PD 986

Reclassification Of Area Shown On Map No. 6-E.
(As Amended)
(Application No. 18002)
(Common Address: 300 -- 368 E. 26th St., 2500 -- 2558 S. Dr. Martin Luther King, Jr. Dr.
And 301 -- 367 E. 25th St.)

*Residential-Institutional Planned Development No. 986,
As Amended.*

Re: **Administrative Relief request for Residential Planned Development No. 986, Eastgate Village, Sub-Areas 1A and 3**

Subarea Map

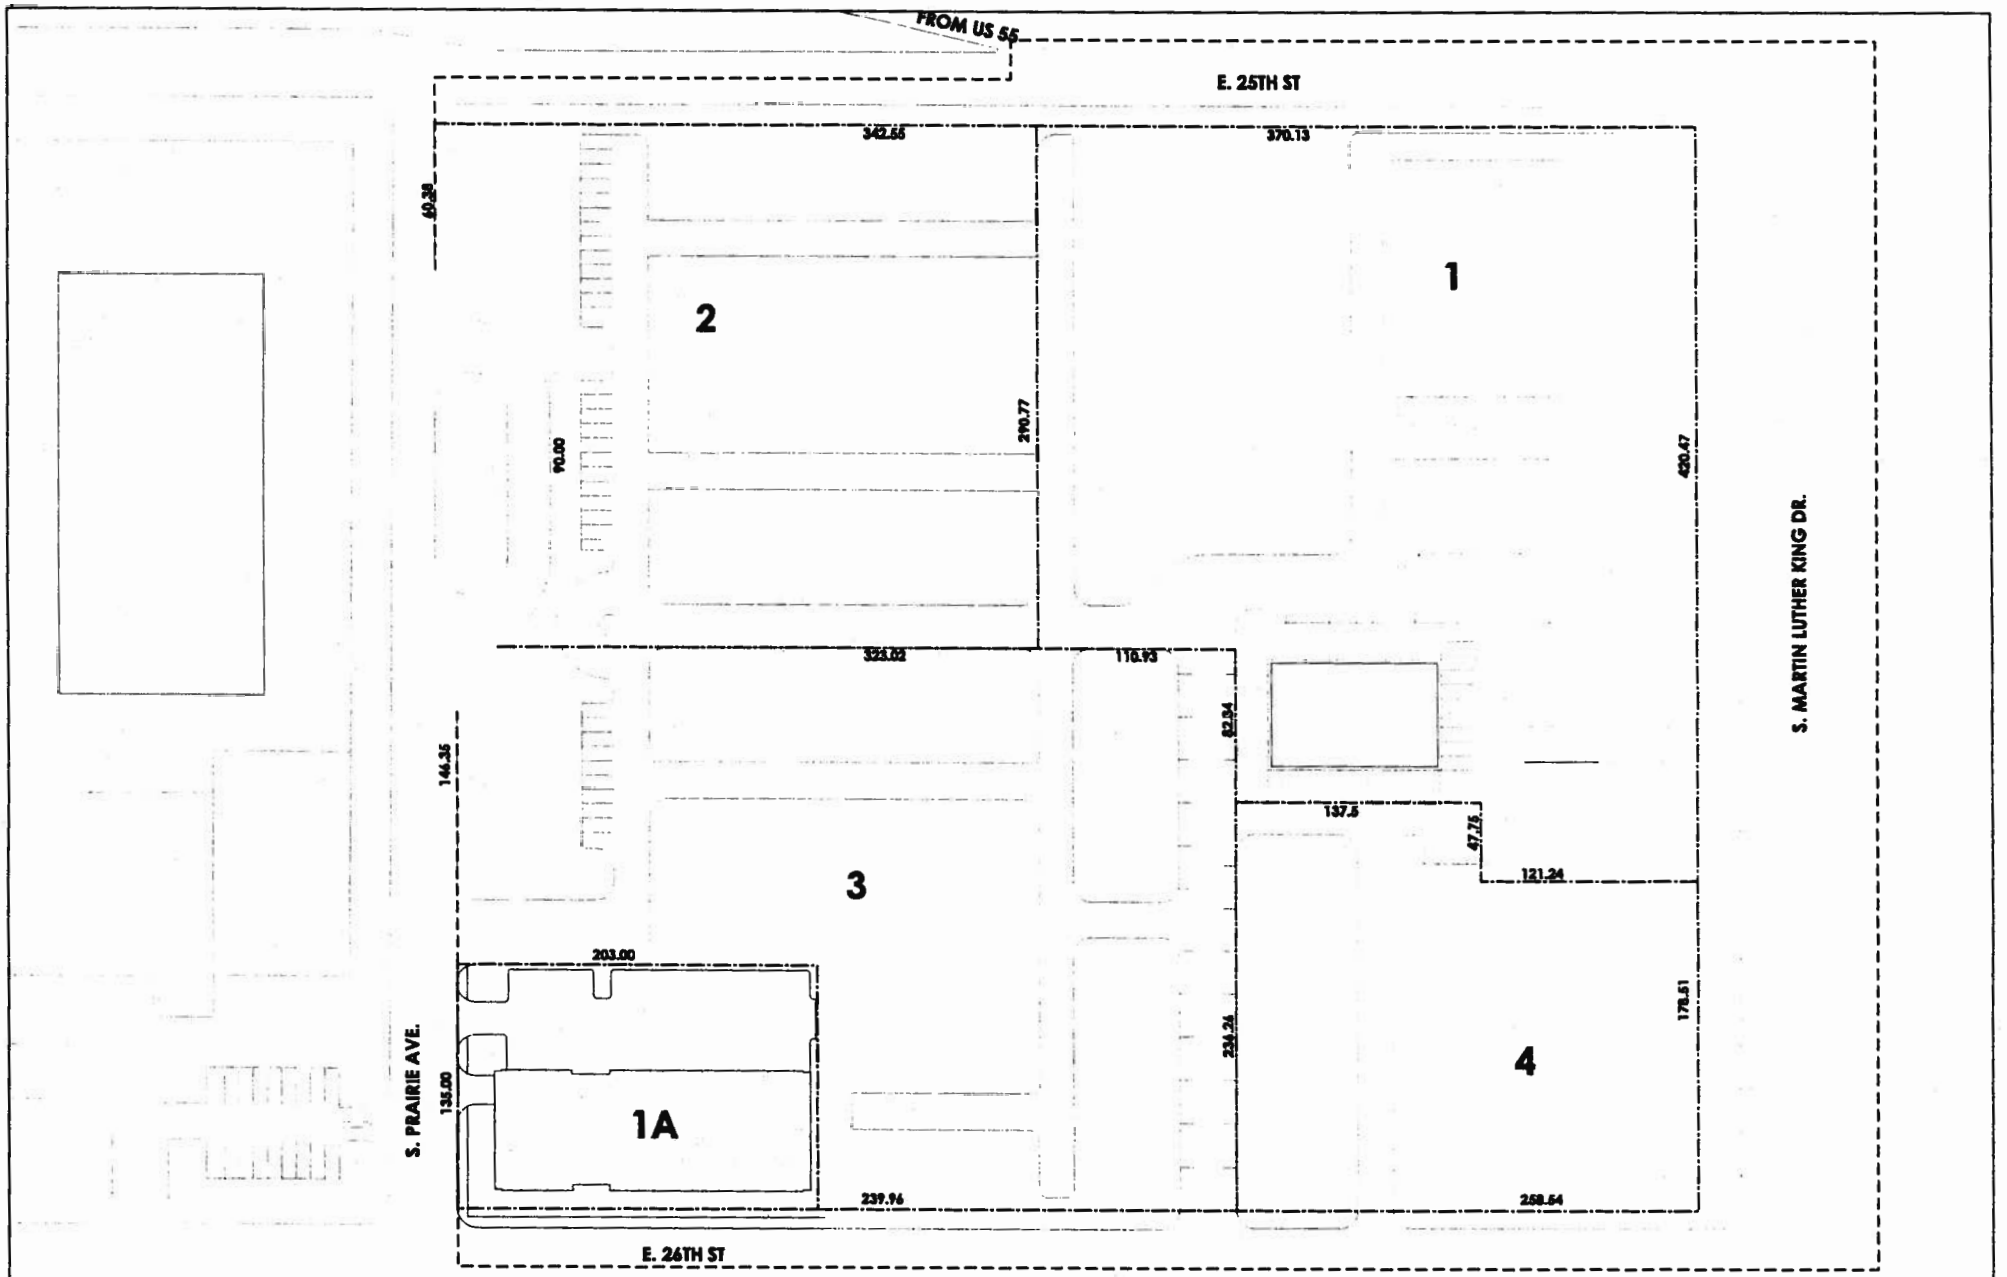
- Substitute a revised Sub-Area Map, dated March 10, 2008, in place of the previously approved Sub-Area Map. The revised Map indicates an increase in the size of Sub-Area 1A and a decrease in the size of Sub-Area 3. Despite the changes to these Sub-areas, you have agreed to abide by the individual Sub-area Floor Area Ratios stated in the original Bulk Table and will not exceed the overall maximum Floor Area Ratio stated in the Bulk Table as stated in an e-mail dated March 18, 2008 hereto attached.
